UNITED STATES DEPARTMENT OF COMMERCE United States Patent and Trademark Office Address: COMMISSIONER FOR PATENTS P.O. Box 1450 Alexandria, Virginia 22313-1450 www.uspto.gov

APPLICATION NO.	FILING DATE	FIRST NAMED INVENTOR	ATTORNEY DOCKET NO.	CONFIRMATION NO.
10/561,532	12/19/2005	Ronald Dekker	NL02 1153 US	9985
	590 04/14/2008 FRONICS NORTH AMERICA CORPORATION		EXAMINER	
INTELLECTUAL PROPERTY & STANDARDS			DURBIN, MICHAEL H	
	370 W. TRIMBLE ROAD MS 91/MG SAN JOSE, CA 95131		ART UNIT	PAPER NUMBER
,			2815	
			MAIL DATE	DELIVERY MODE
			04/14/2008	PAPER

Application No.	Applicant(s)				
Office Action Occurrence	10/561,532	DEKKER ET AL.				
Office Action Summary	Examiner	Art Unit				
	MICHAEL DURBIN	2815				
The MAILING DATE of this communication app Period for Reply	ears on the cover sheet with the c	orrespondence address				
A SHORTENED STATUTORY PERIOD FOR REPLY IS SET TO EXPIRE 3 MONTH(S) OR THIRTY (30) DAYS, WHICHEVER IS LONGER, FROM THE MAILING DATE OF THIS COMMUNICATION. - Extensions of time may be available under the provisions of 37 CFR 1.136(a). In no event, however, may a reply be timely filed after SIX (6) MONTHS from the mailing date of this communication. - If NO period

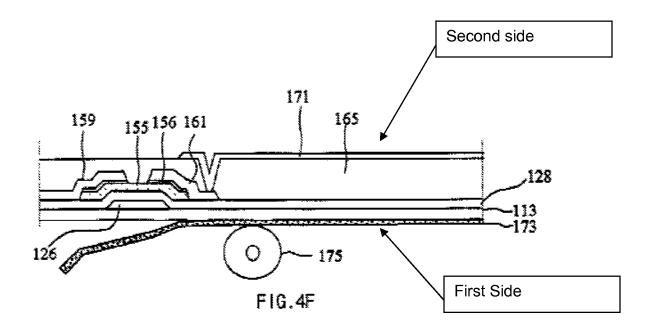
7. **Regarding claim 1**, Lee discloses and shows (figs. 4a-4f) a flexible monolithic electronic device ([0014]) provided with an insulating layer of electrically insulating material (165) having a first side and an opposed second side (as denoted in the figure above), which insulating layer (165) is provided with a first aperture (drain contact hole 167 in fig. 4d) extending from the first to the second side; an active layer (155) of a semiconductor material on the first side of the insulating layer, in and on which active layer at least one switching element is defined (a thin film transistor), which element is provided with a first electrode in the active layer (161); a flexible coating acting as a protective cover for the at least one switching element (173); and a functional layer (liquid crystal, LC, layer not depicted) being present on the second side of the insulating layer and being electrically connected to the first electrode through the first aperture in the insulating layer (via conductor 171). Though the LC layer is not depicted in the

8. **Regarding claims 3** – **5**, the functional layer is an electro-optical layer (LC layer) which constitutes, in conjunction with a switching element (the TFT formed with gate 126), a display pixel (as seen in fig 1 and discussed [0005 – 0012, 0030]). An electrically conductive layer (171), a pixel electrode, is present between the active layer (155) and the functional layer (the LC material between the array substrate seen in figs. 4a-4f and the color filter substrate shown in fig. 1). Further, the display pixel comprises a capacitor (a parasitic capacitor) having a first capacitor electrode and a second capacitor electrode, wherein the first electrode is present in the electrically conductive layer (first electrode is 171) and which the second capacitor electrode is defined in the active layer (115), the insulating layer acting as a dielectric there between (parasitic capacitor extant between the source electrode 159 and the pixel electrode 171).
